# PARKER AND PINE FILING NO. 1 LOT 2 – SITE PLAN

MURPHY OIL USA, INC.

COVER SHEET  
 MURPHY EXPRESS  
 12405 SOUTH PARKER ROAD  
 PARKER  
 COLORADO

HORIZONTAL CONTROL PLAN  
 MURPHY EXPRESS  
 12405 SOUTH PARKER ROAD  
 PARKER, COLORADO

SHEET NO. C-1.1

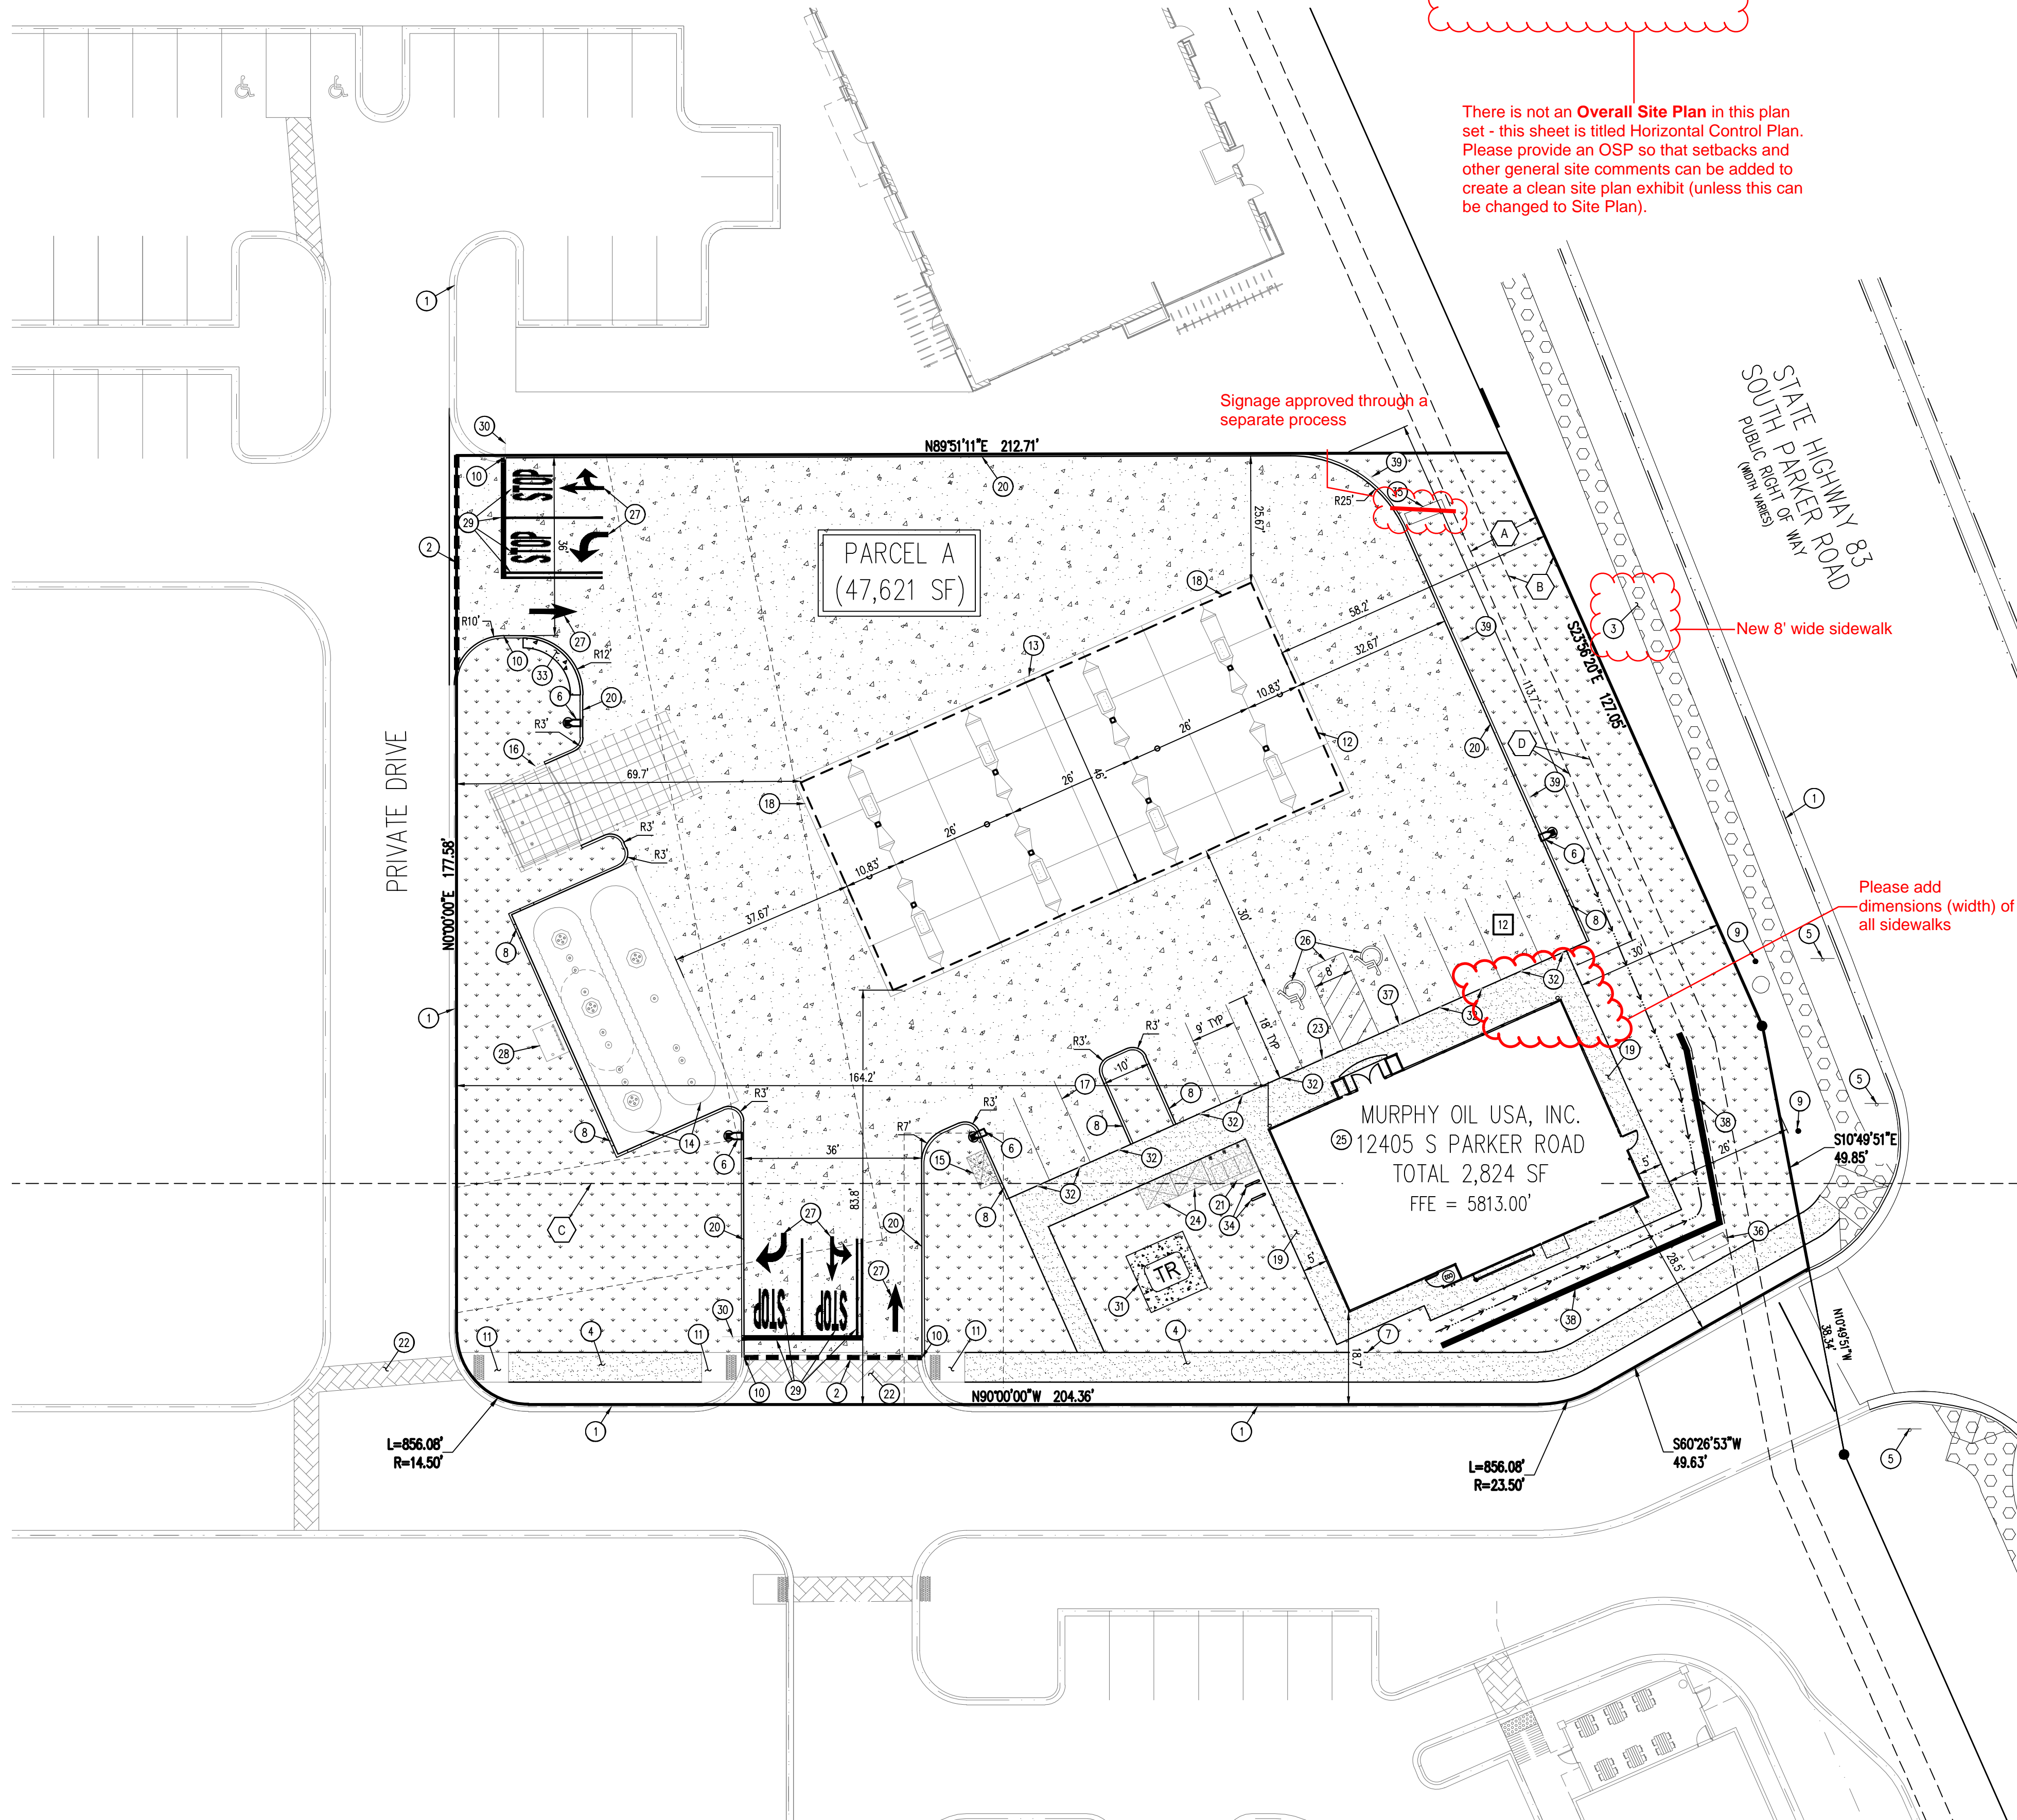
There is not an Overall Site Plan in this plan set - this sheet is titled Horizontal Control Plan. Please provide an OSP so that setbacks and other general site comments can be added to create a clean site plan exhibit (unless this can be changed to Site Plan).

Please add dimensions (width) of all sidewalks

SHEET NO. C-3.5

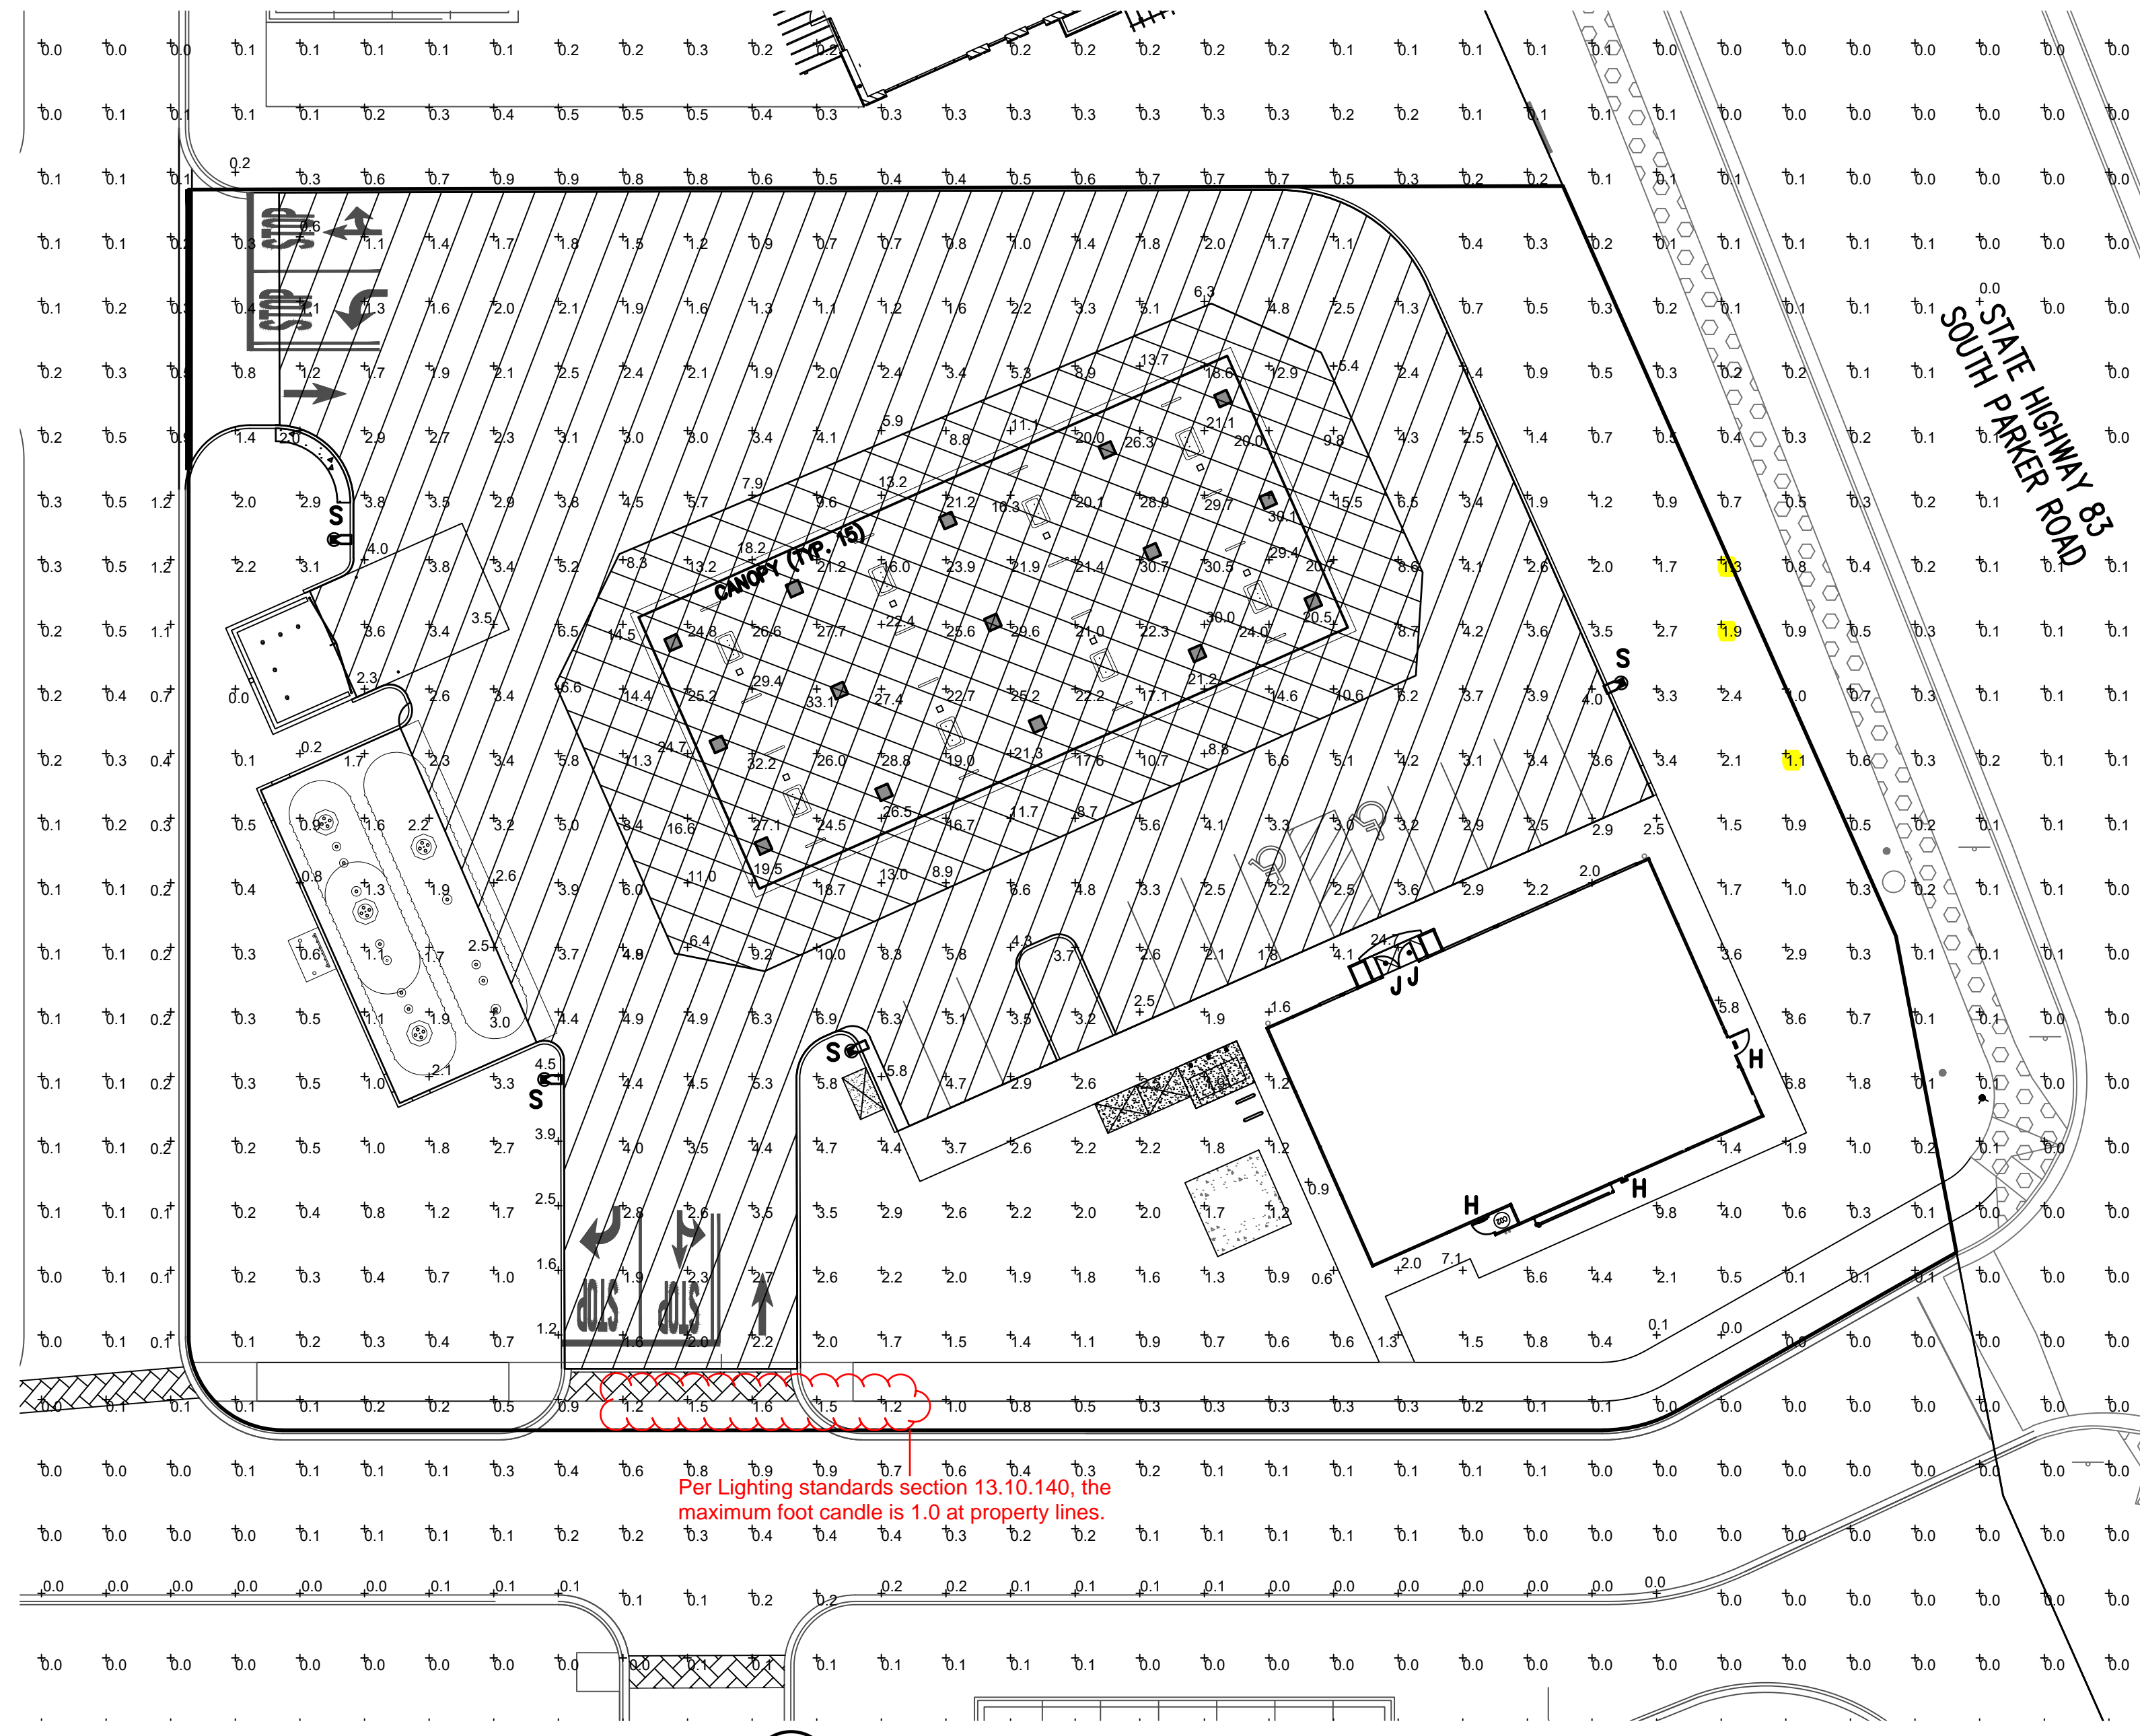
Lighting cannot exceed the height of the building (18.5').

SHEET NO.  
**L1.1**

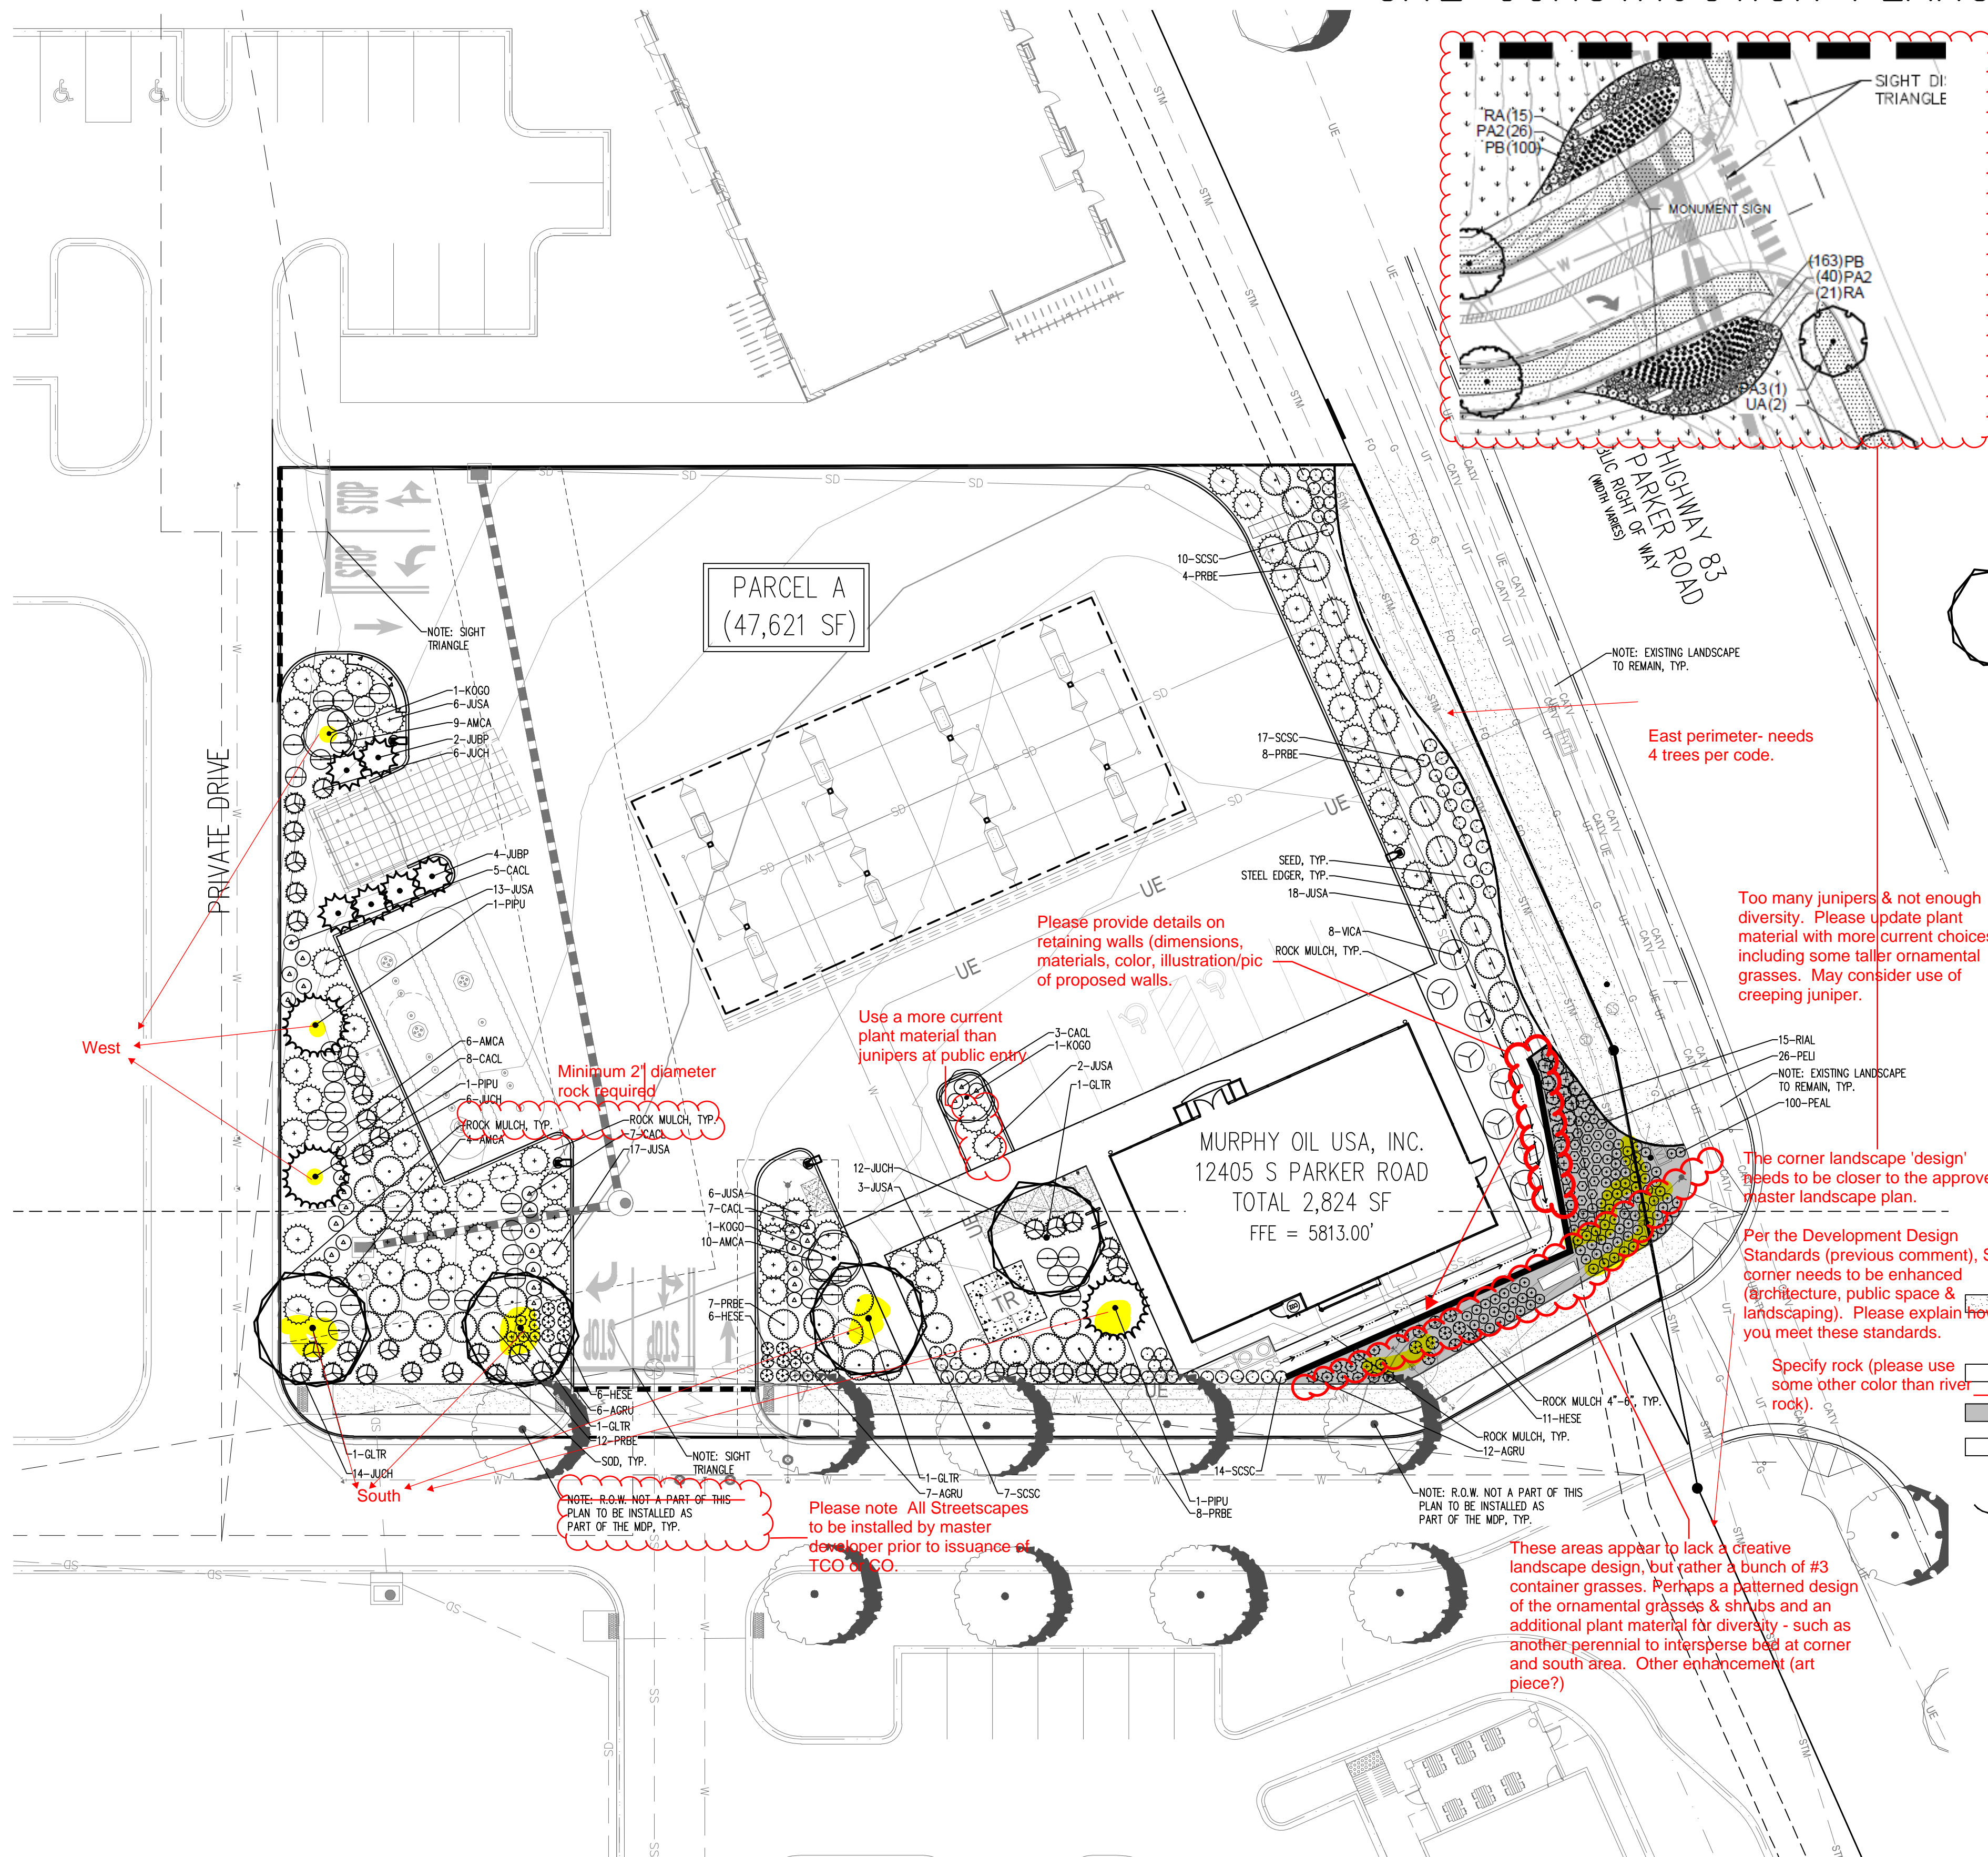
The south perimeter landscape requirement is separate from the required Streetscape (master developer to install). You are required to provide the south perimeter landscaping. Please add these trees & shrubs

Only 3 trees are provided on plan. Please add 2 more trees.

Please add: Any & all substitutions MUST be approved by the Town prior to installation.

Needs to be 12 trees plus 13 site perimeter trees per table above. Site perimeter trees require minimum 40% evergreen trees (13.06.070(q)).

Ensure 'Shademaster' & not a 'Sunburst' is installed as they are prohibited.

This % should be included in deciduous trees percentage and not on its own.

Wood mulch around all plants or just trees?

Incorporate some areas with wood mulch for variety of ground cover?

Landscape regulations (13.06.070(1)(3)) requires natural cedar fiber mulch
